ADDENDUM No. 6

Project Name: **TOWN OF HILTON HEAD ISLAND
REQUEST FOR PROPOSALS
RFP 2016-0015 FIRE STATION TWO**

Date: July 8, 2016
From: Rosenblum Coe Architects, Inc.
1643 Means St.
Charleston, SC 29412
843.577.6073 (p)

1 SECTION THROUGH DISPLAY CABINET
 SK-1 SCALE: 1" = 1'-0"

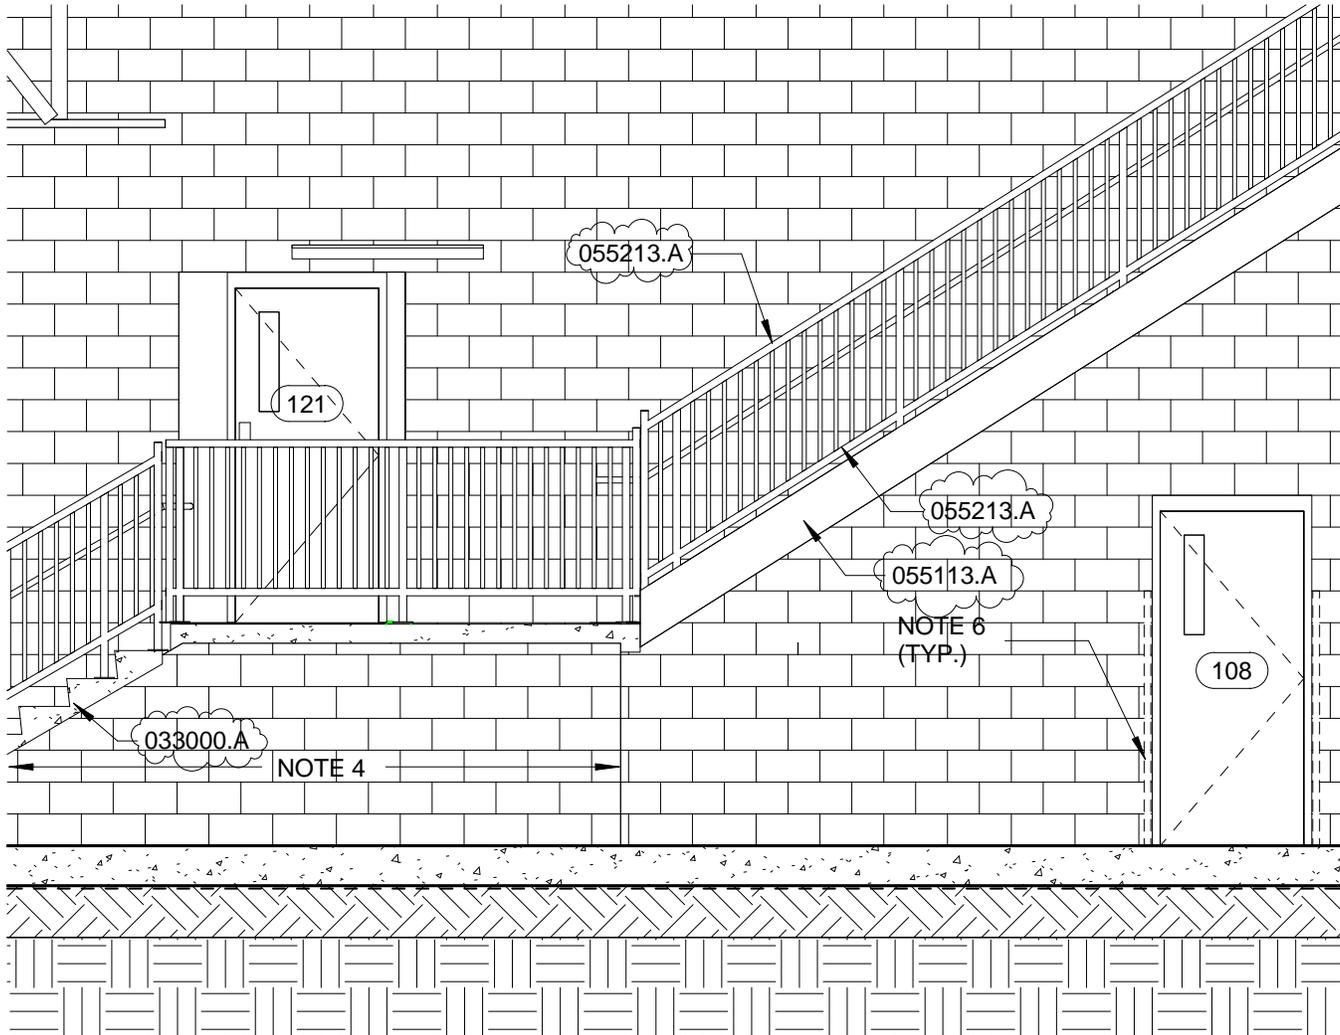
1. Drawing E6/A401: Add a section mark through display cabinets to reference 1/SK-1(attached to this Addendum).
2. Drawing C3/A300: Add keynotes to stairs as shown on 1/SK-2(attached to this Addendum.)

SECTION THROUGH DISPLAY CASEWORK (SEE E6/A401)

ADDENDUM 6 - EXTERIOR STAIR SECTION DETAIL

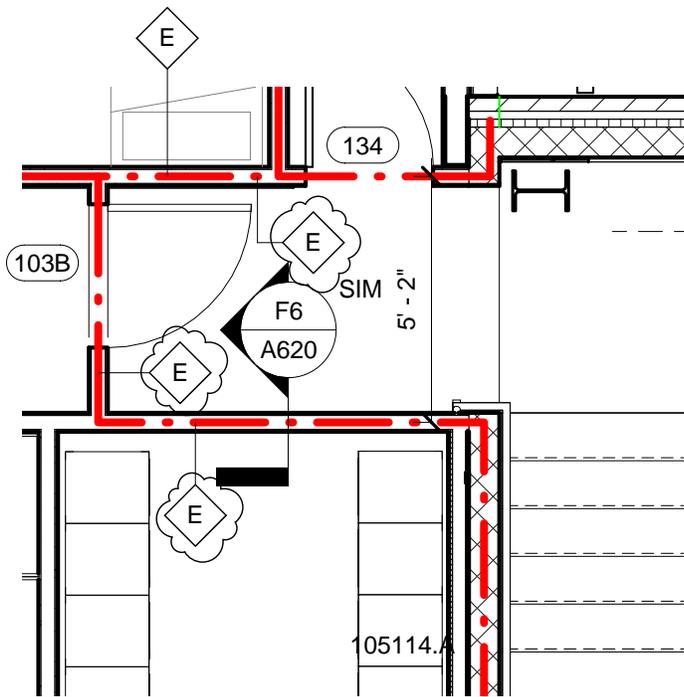
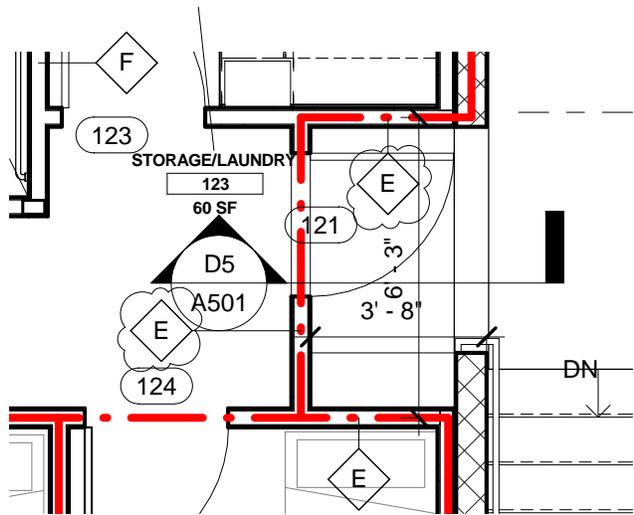
3. Drawing E1/A103: Replace this drawing with 1/SK-3(attached to this Addendum.)
4. Drawing F1/A102: Revise wall tags to match those shown in SK-4(attached to this Addendum.)

EXTERIOR STAIR SECTION REVISED (SEE E1/A103)

**M401 HVAC
SCHEDULES**

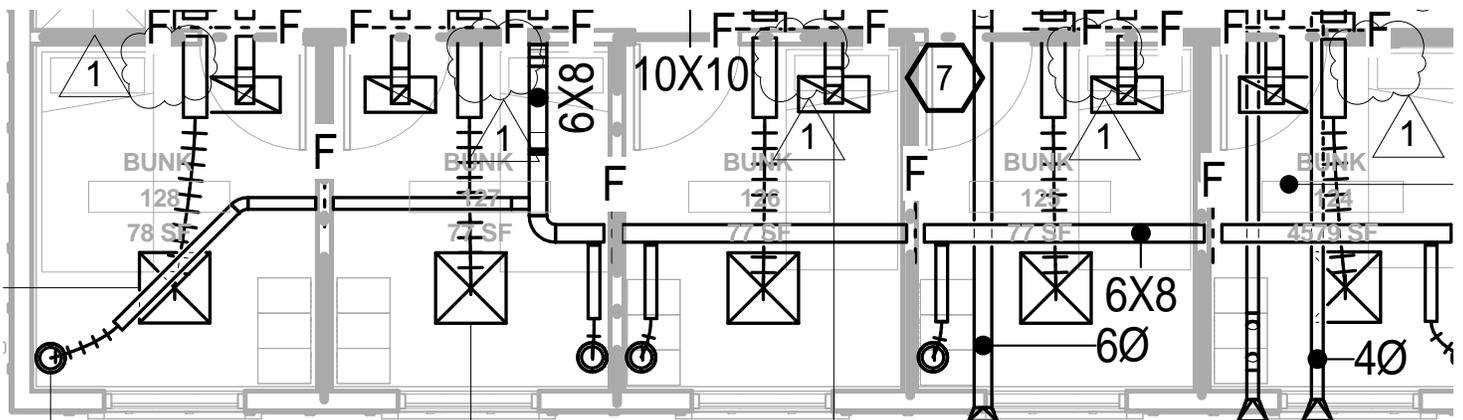
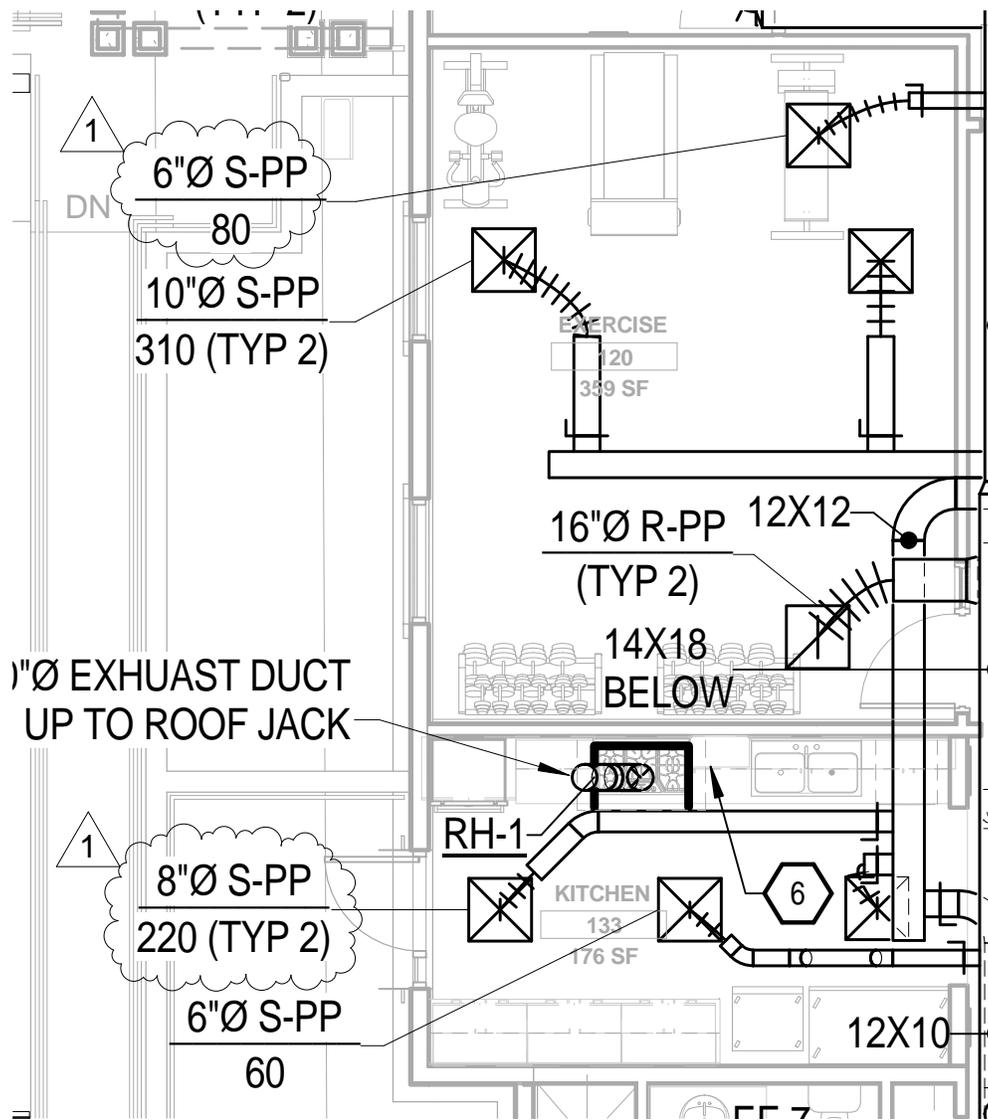
5. Sheet M401, HVAC Schedules: Revise as shown on attached sketch SK-M-001.
6. Sheet M101 ,HVAC Ductwork Plan & Mezzanine: Revise as shown on attached sketch SK-M-002.

SK-M-003

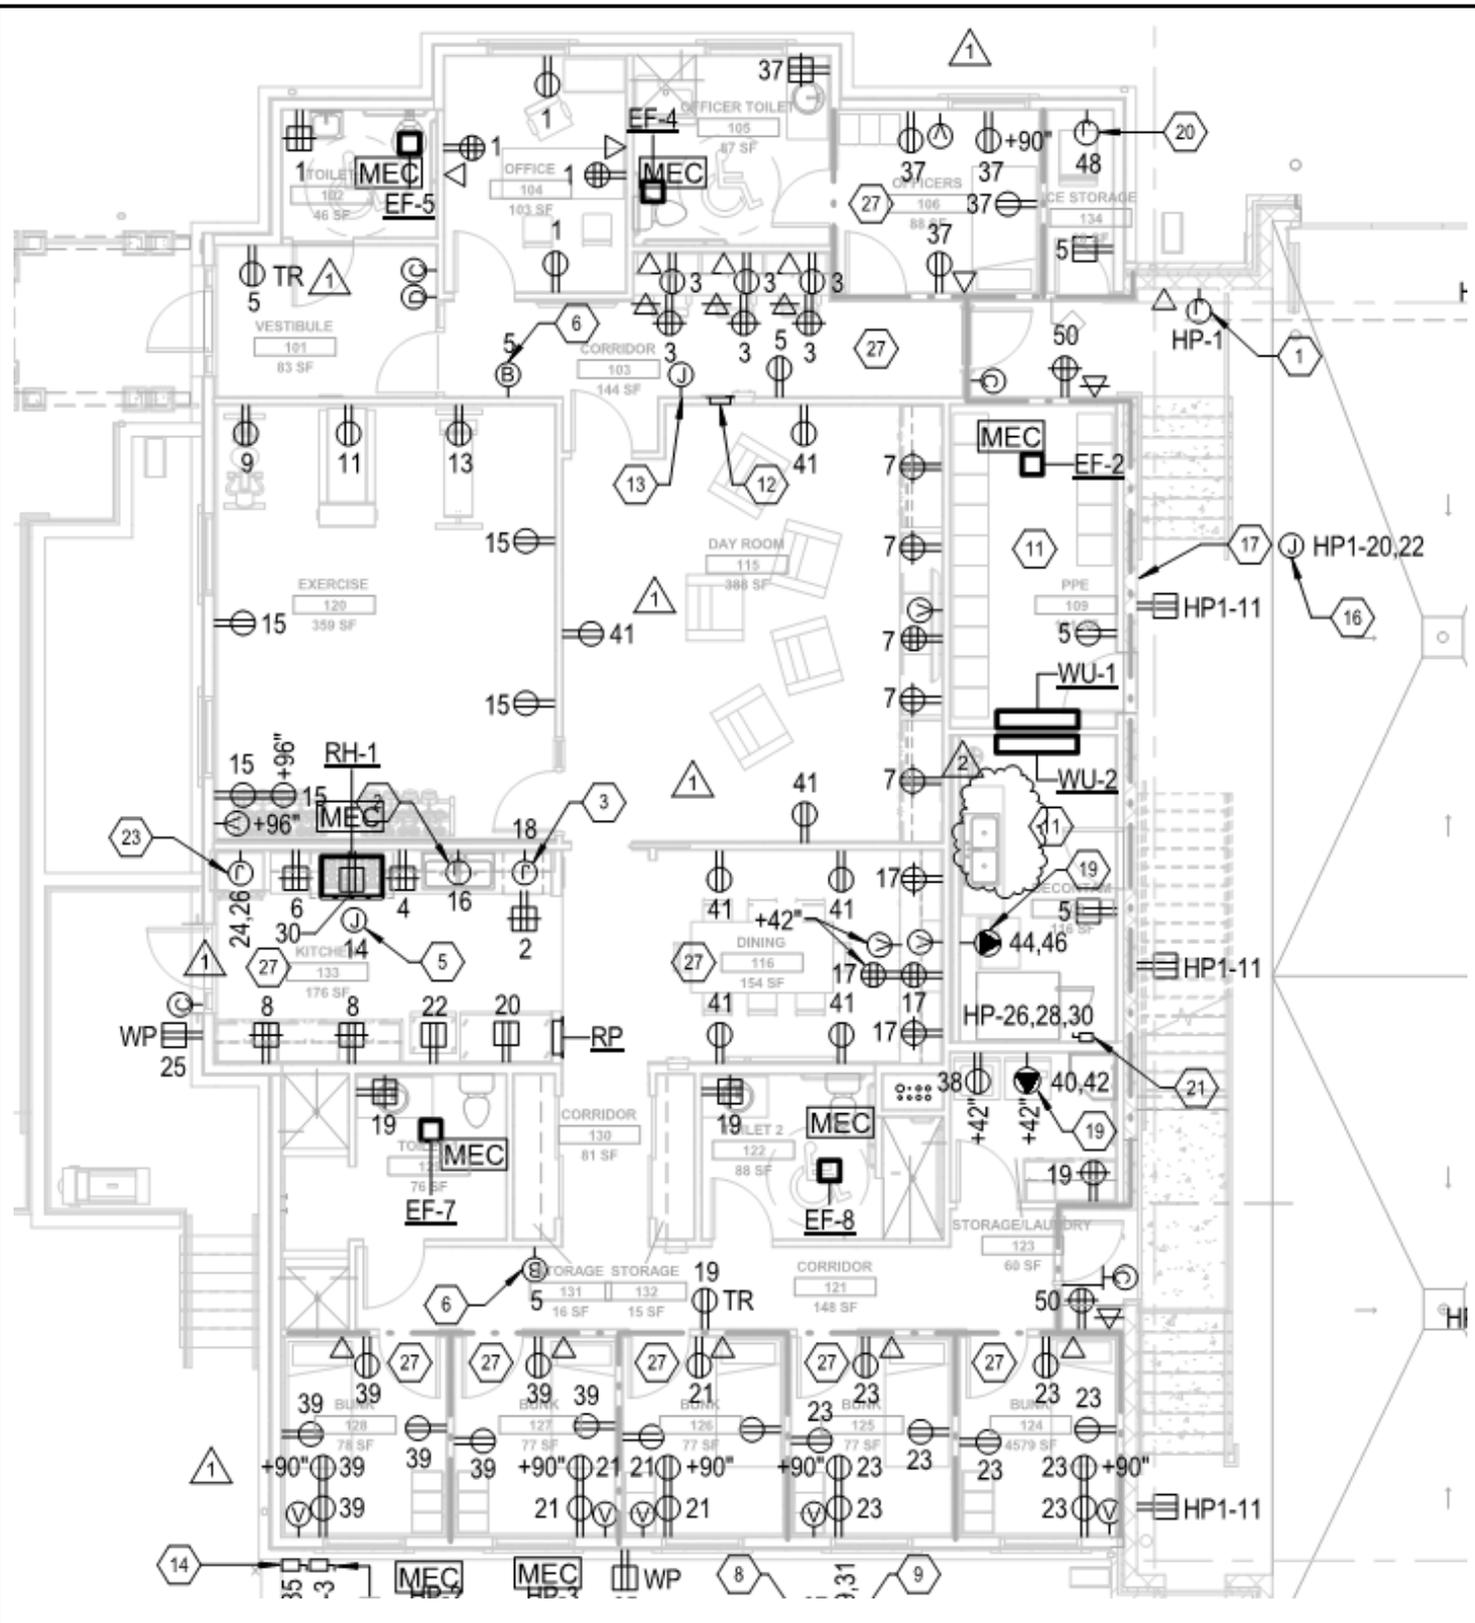
7. Sheet M101, HVAC Ductwork Plan 7 Mezzanine: Revise as shown on attached sketch SK-M-003.
8. Sheet E101, Electrical Power Plan & Mezzanine: Revise as shown on attached sketch SK-E-007.

E101 ELECTRICAL SCHEDULES

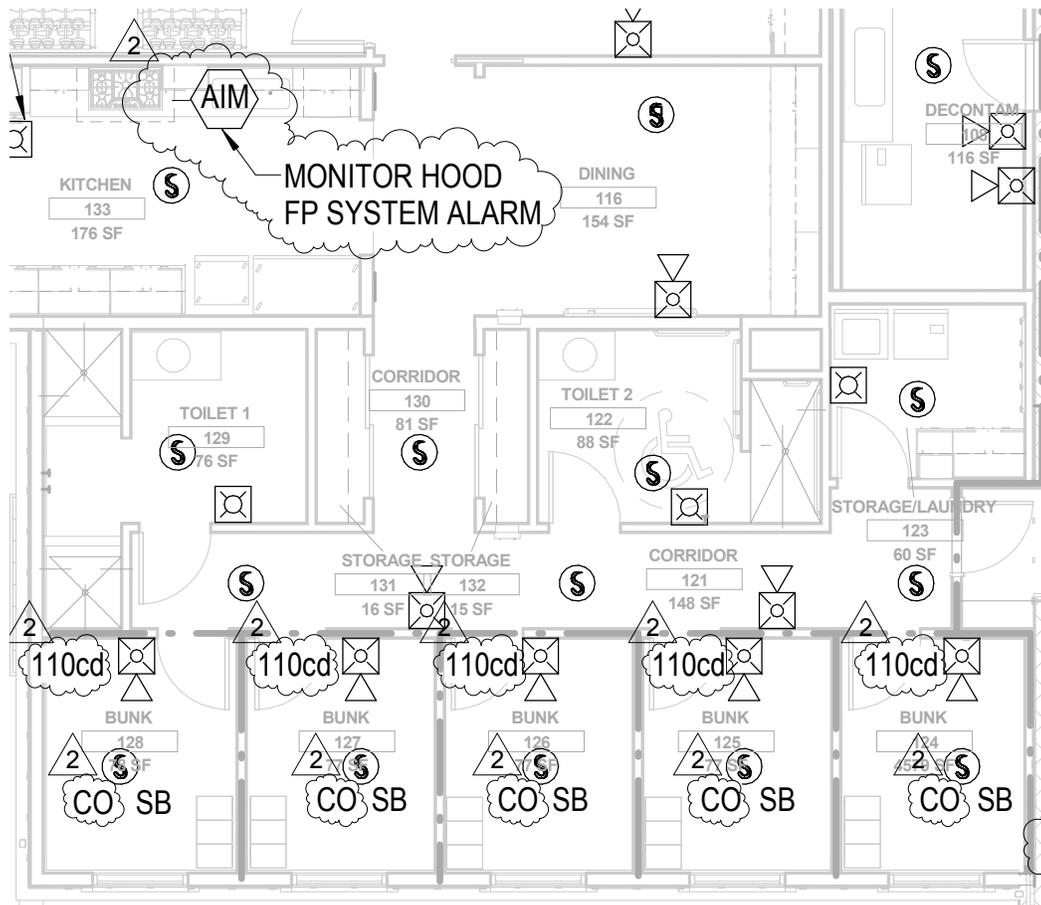
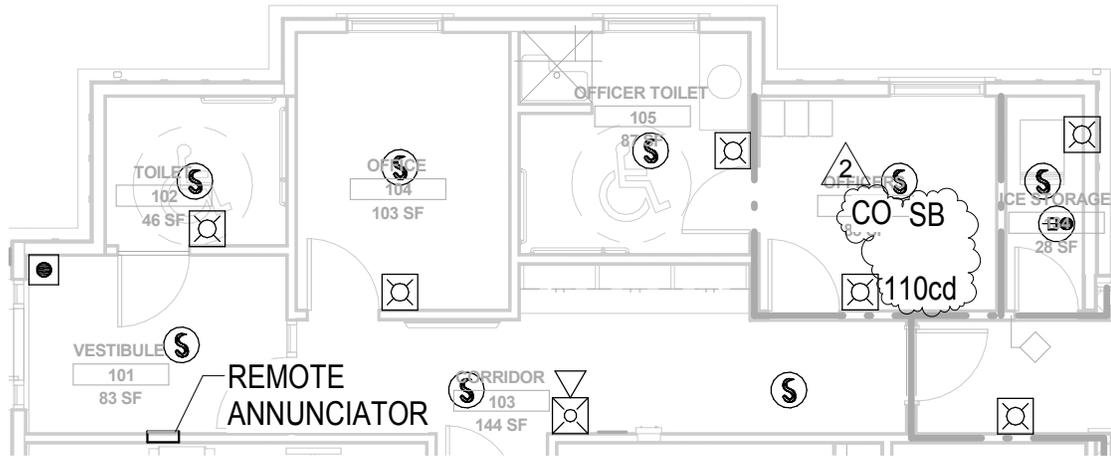
11. Sheet E101, Electrical Schedules: Revise as shown on attached sketch SK-E-010.
12. Sheet E101, Electrical Schedules: Revise as shown on attached sketch SK-E-011.

**FIRE ALARM DRAWING
FA101**

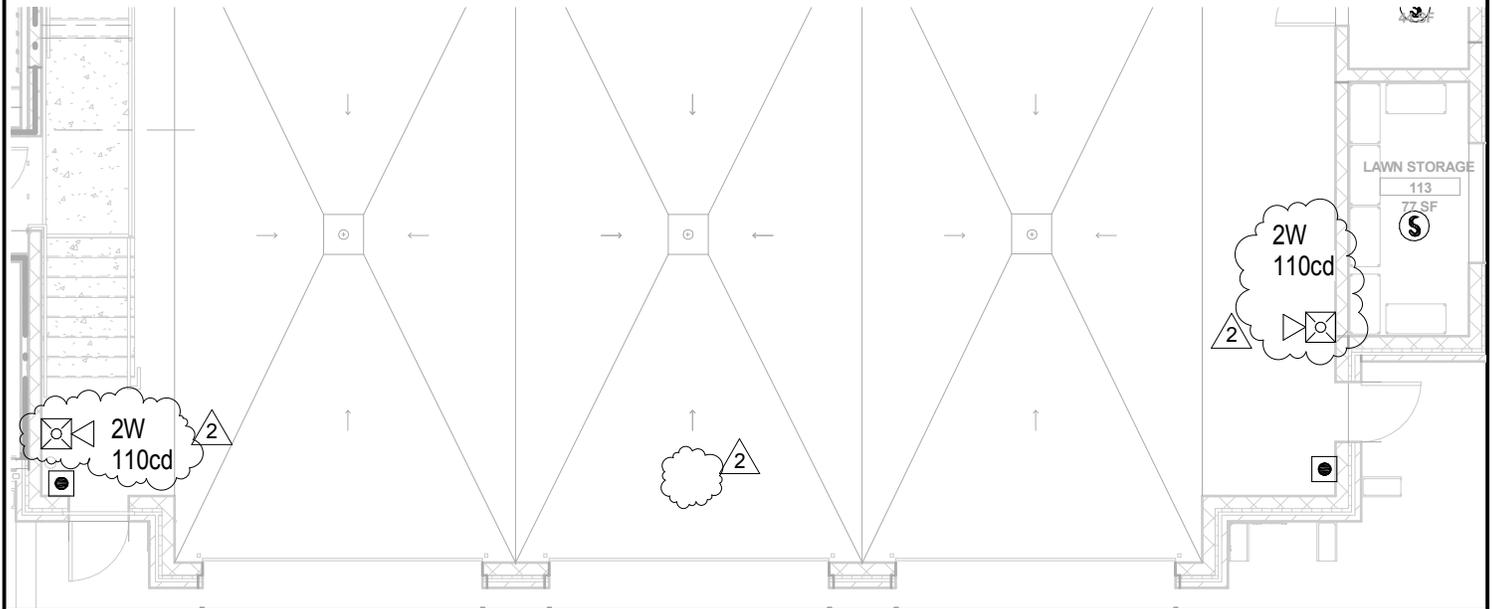
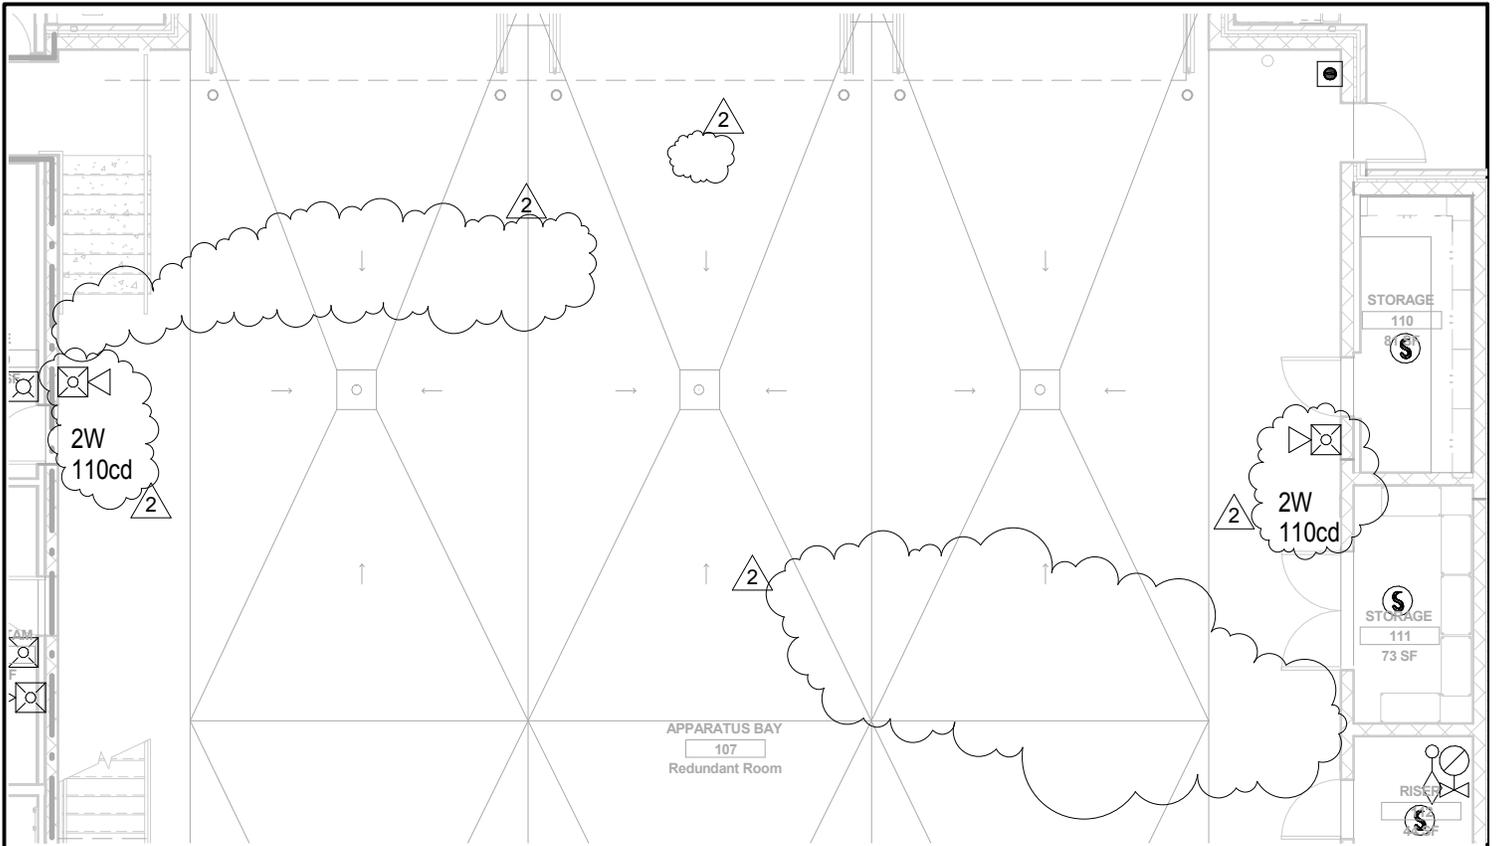
13. Sheet FA101, Fire Alarm Plan & Mezzanine: Revise as shown on attached sketch SK-FA-001.
14. Sheet FA101, Fire Alarm Plan & Mezzanine: Revise as shown on attached sketch SK-FA-002.

FIRE ALARM DRAWING FA101 MEZZANINE	
14638	SK-FA-003
JLH	
08 JUL 2016	NOT TO SCALE

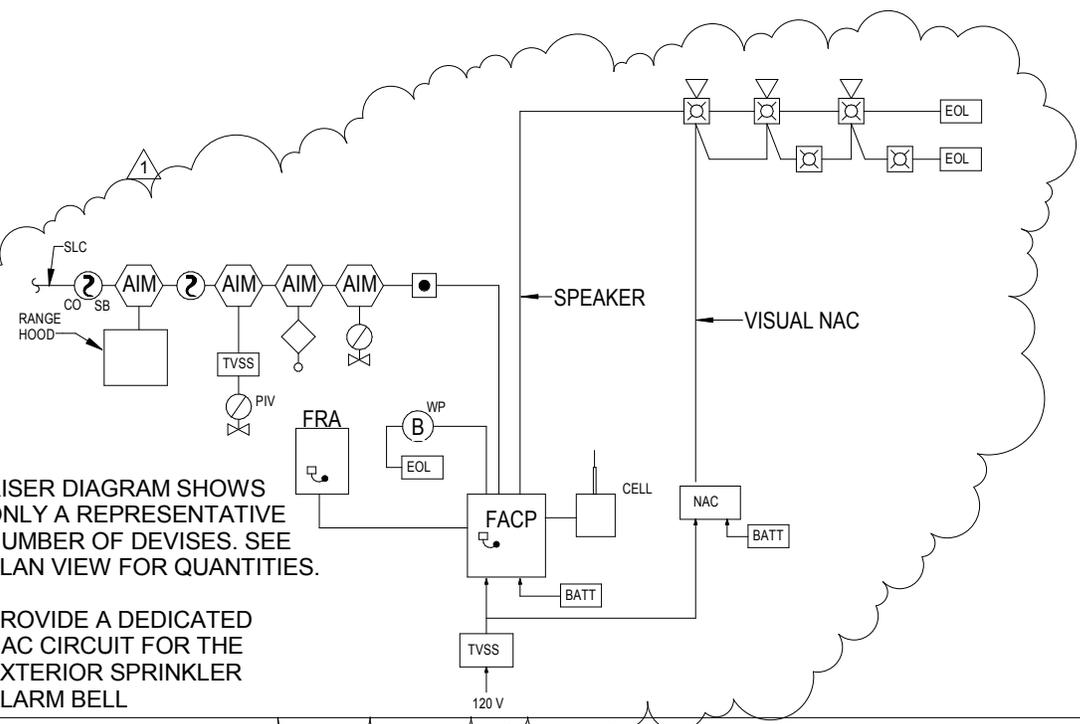
15. Sheet FA101, Fire Alarm Plan & Mezzanine: Revise as shown on attached sketch SK-FA-003.
16. Sheet FA001, Fire Alarm Riser and Notes: Revise as shown on attached sketch SK-FA-004.
